ADDENDUM NO. 2

MLK ELEMENTARY SCHOOL WELLNESS CENTER BAKERSFIELD CITY SCHOOL DISTRICT

Project No.: 5527 DSA File No. 15-6 DSA App No. 03-122605 December 19, 2024

A3.10

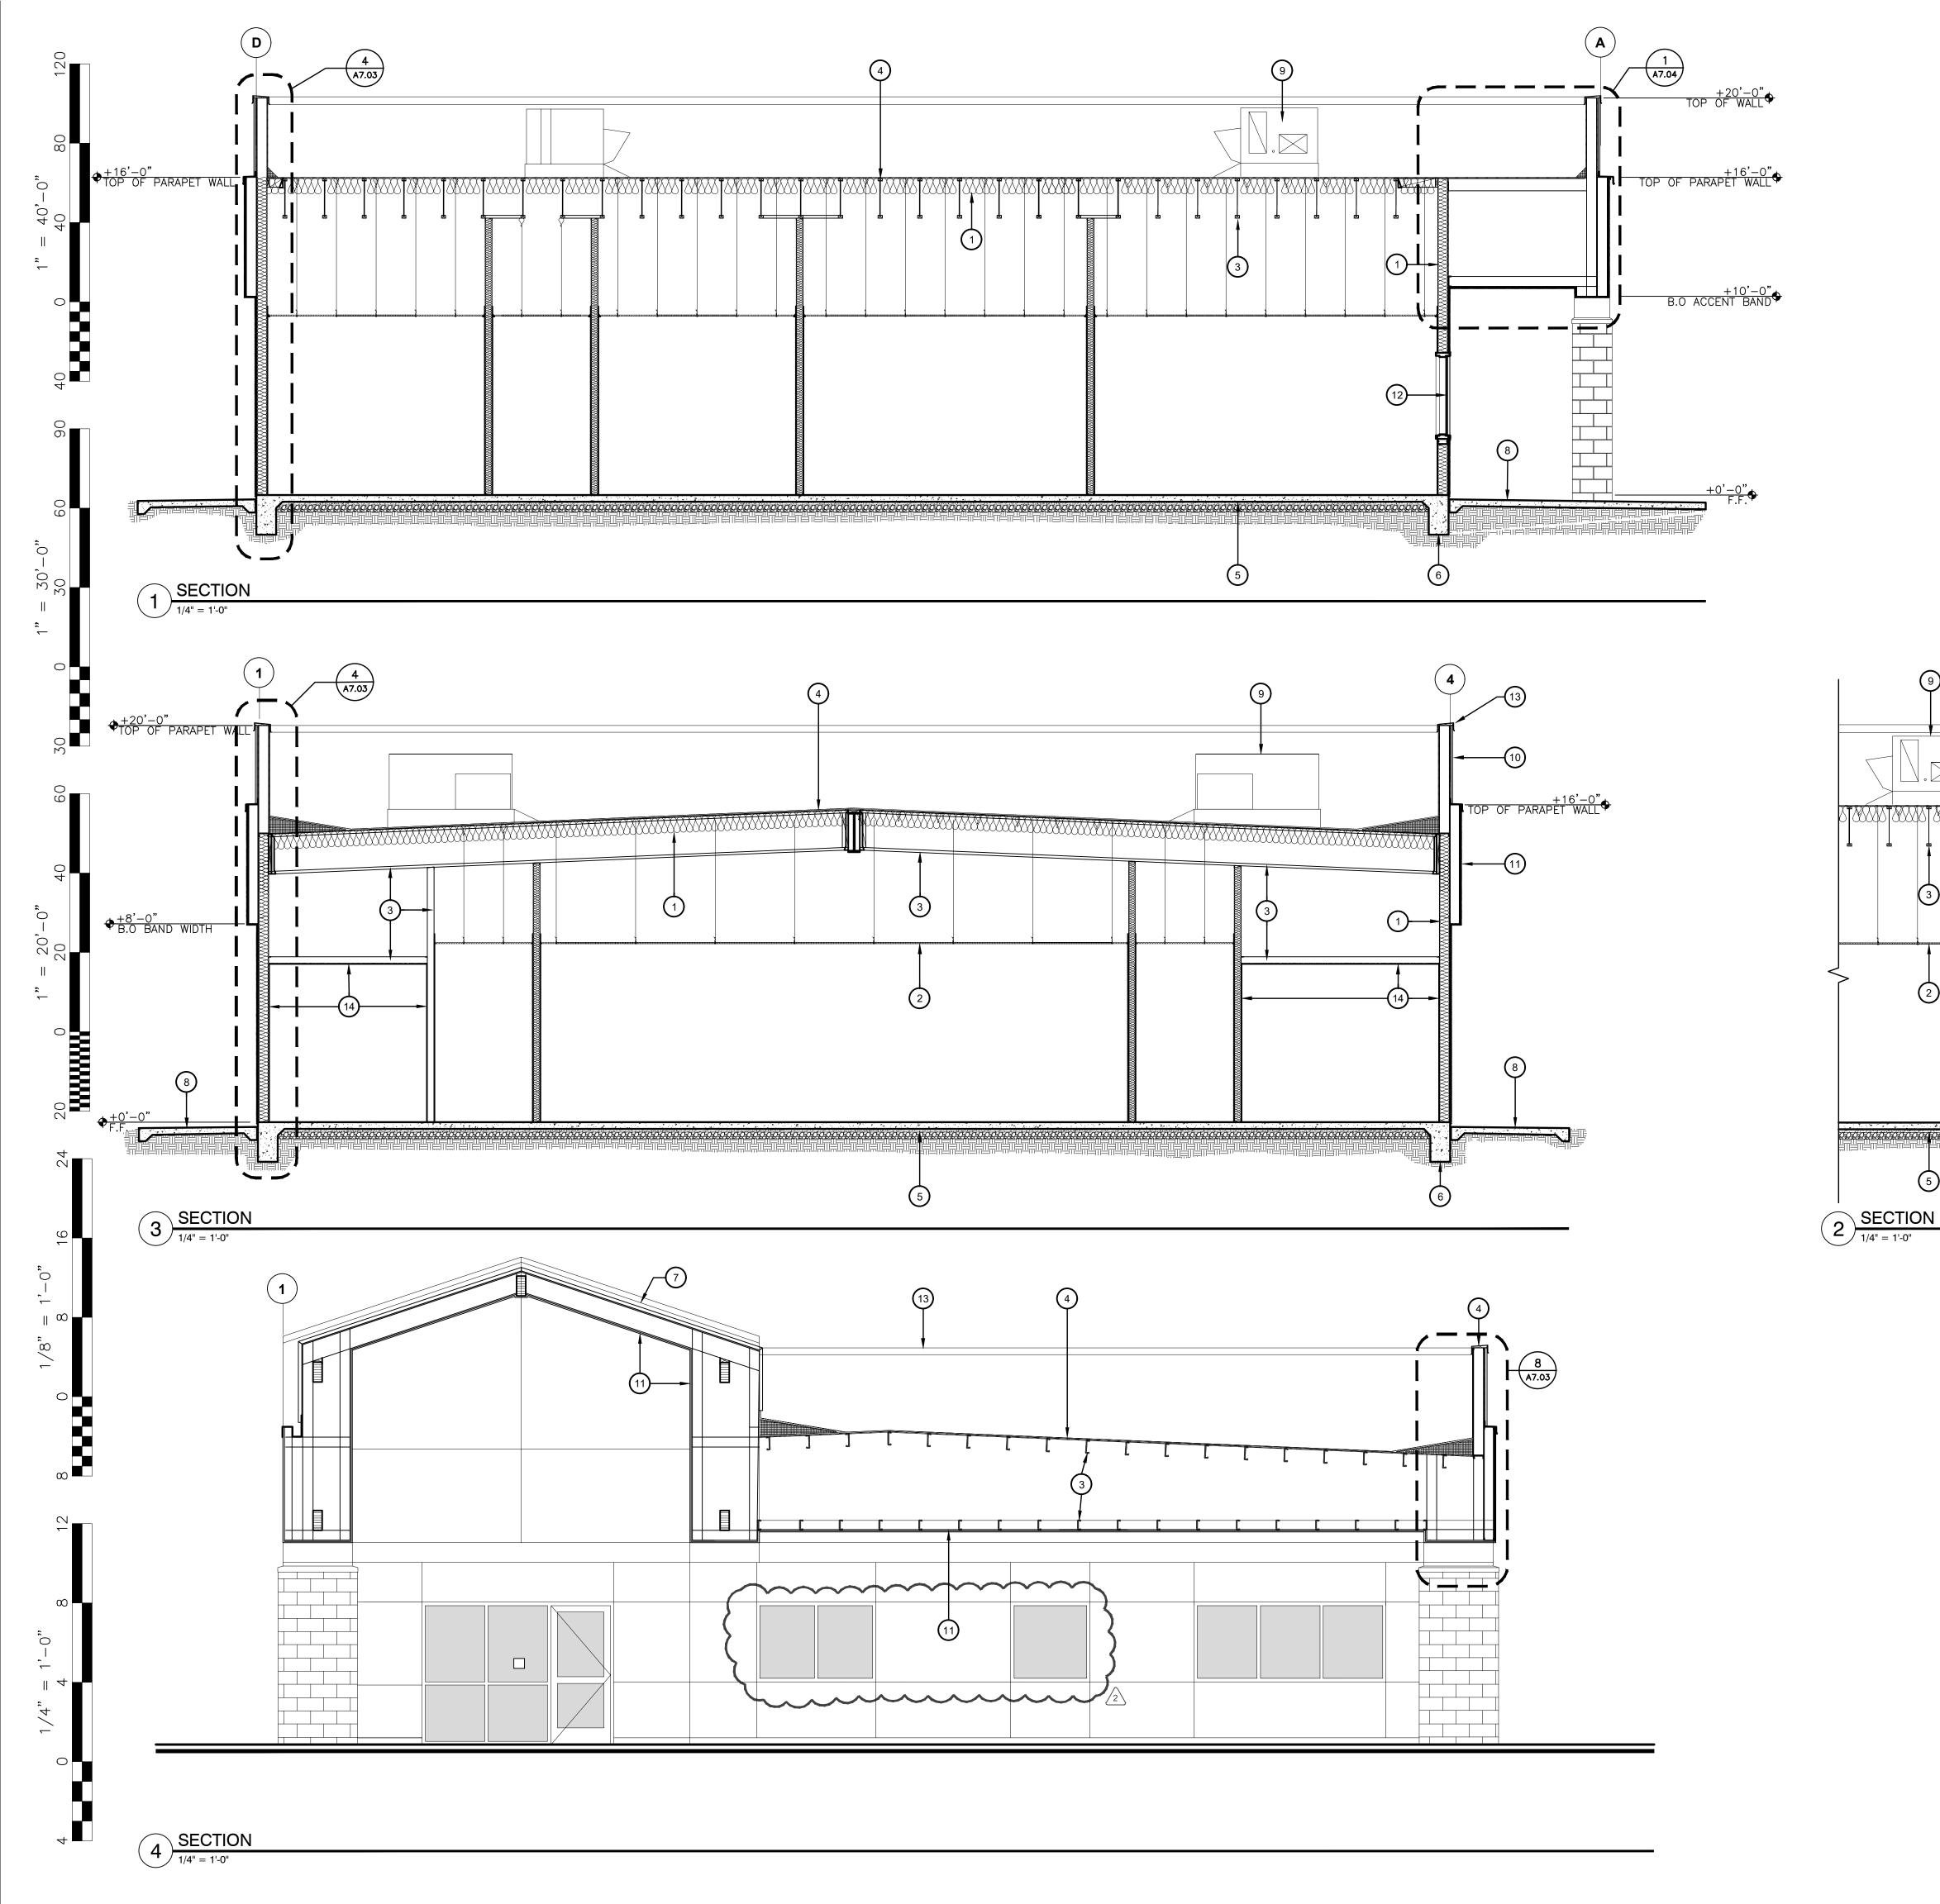
- 11. TVs have been added to rooms 101 and 105.
- **2-13 DRAWINGS, SHEET A3.10 EXTERIOR ELEVATIONS:** Note the following changes (See A3.10 addendum 2 drawing):

- 1. Window in elevation 4/A3.10 has changed.
- **2-14 DRAWING, SHEET 3.11 SECTIONS:** Note the following changes (See A3.11 Addendum 2 drawing)
 - 1. Windows in section 4 have changed.

INTERIOR ELEVATIONS

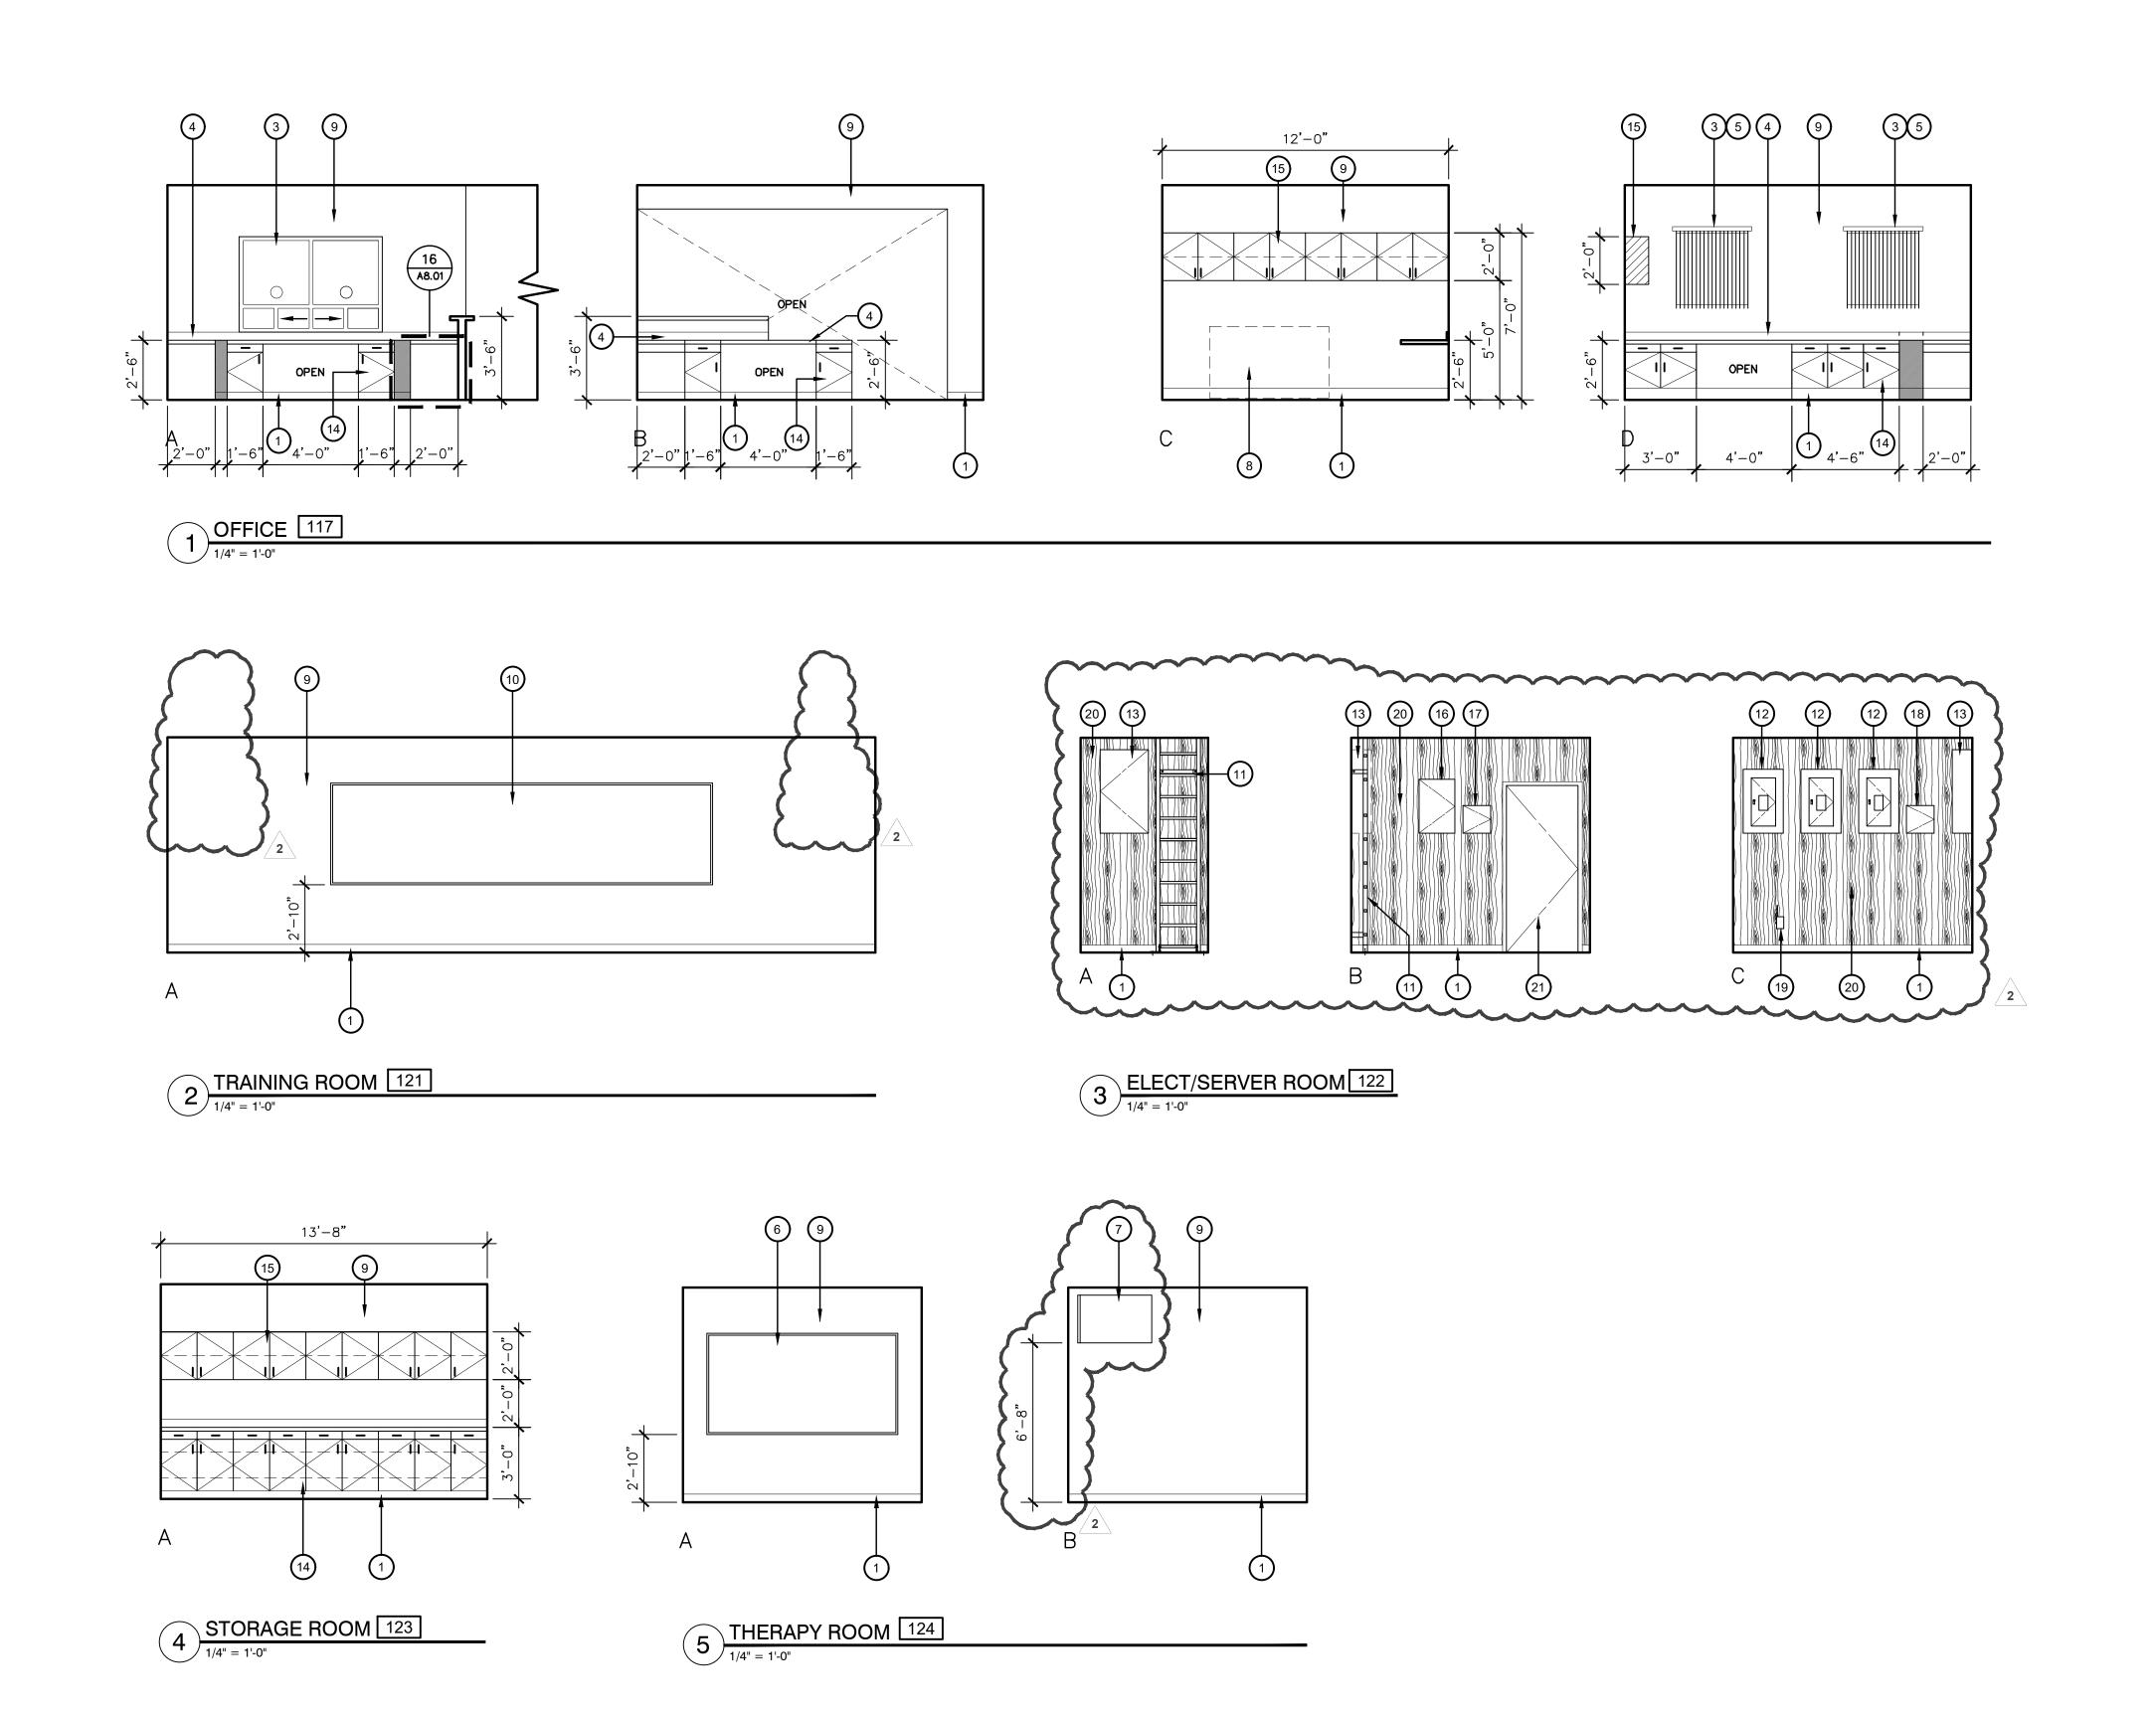
- **2-16 DRAWING, SHEET A5.10 INTERIOR ELEVATIONS:** Note the following changes (See A5.10 addendum 2 drawings):
 - 1. Elevation "B" lobby 101:
 - i. Add TV. See keynote 34.

- 2. Elevation "C" lobby 101:
 - i. Add TV. See keynote 34.
 - 3. Elevation "C" unisex toilet 104:
 - Add pass through cabinet. See keynote 33.
 - 4. Exam rooms 106, 108, 112 and 107, 109, 110:

- i. Remove base cabinets. Provide countertop with drawers.
 - Medical assistant office 105:
 - i. Add elevation "B" for added cabinets.
 - Modify elevation "A" to add TV.

- 6. Delete elevations office room 116.
- **2-17 DRAWING, SHEET A5.11 INTERIOR ELEVATIONS:** Note the following changes (see A5.11 addendum 2 drawing):
